## Interior - Creaking Noises From The Dash Area

2017483/3

December 4, 2008.

Supersedes Technical Service Bulletin Group 85 number 08-03 dated June 4, 2008 for reasons listed below.

**Figure 1.** The defroster trim clips, plain (above) and wrapped with textile tape (below).

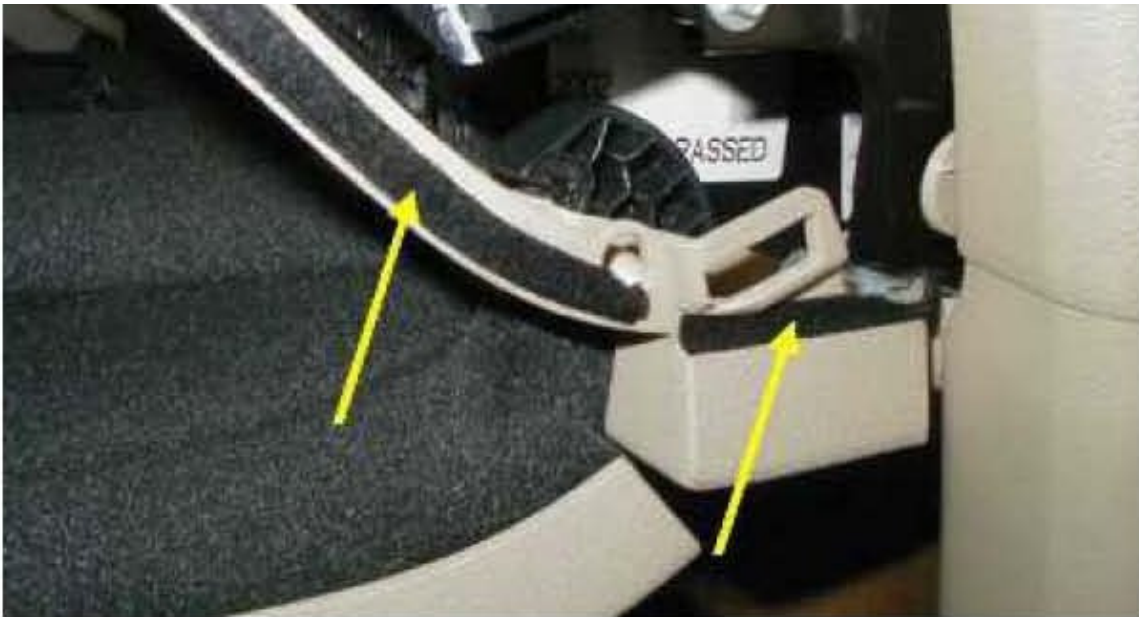
Condition 1: Creaking noises from the upper air (defrost) outlet in the instrument panel.

Condition 1: Defroster trim creaks due to poor air outlet fit in the instrument panel.

Wrap textile tape around all defroster trim clips (Figure 1).

**Figure 2. Areas to apply felt.**

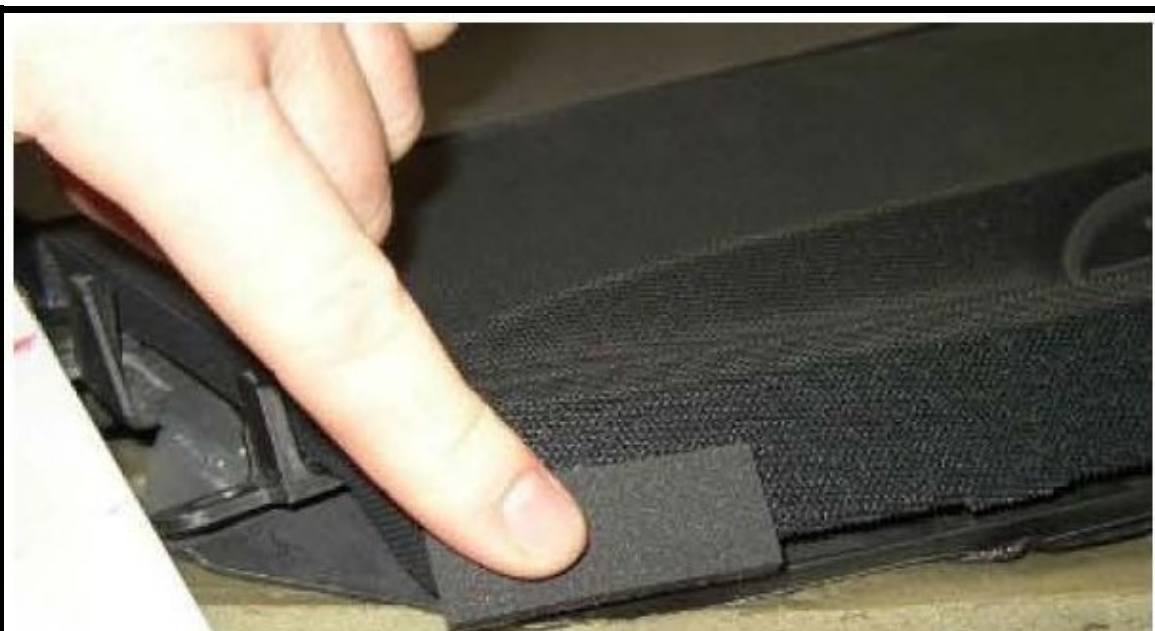
Condition 2: Creaking noises from the right side of the instrument panel cover area.

Condition 2: The right instrument panel cover contacts the glove compartment.

1. Check the position of the glove compartment and apply two pieces of felt material (533 867 910A) as shown in the illustration.
2. Spray the clips of the side cover with a Teflon based lubricant.
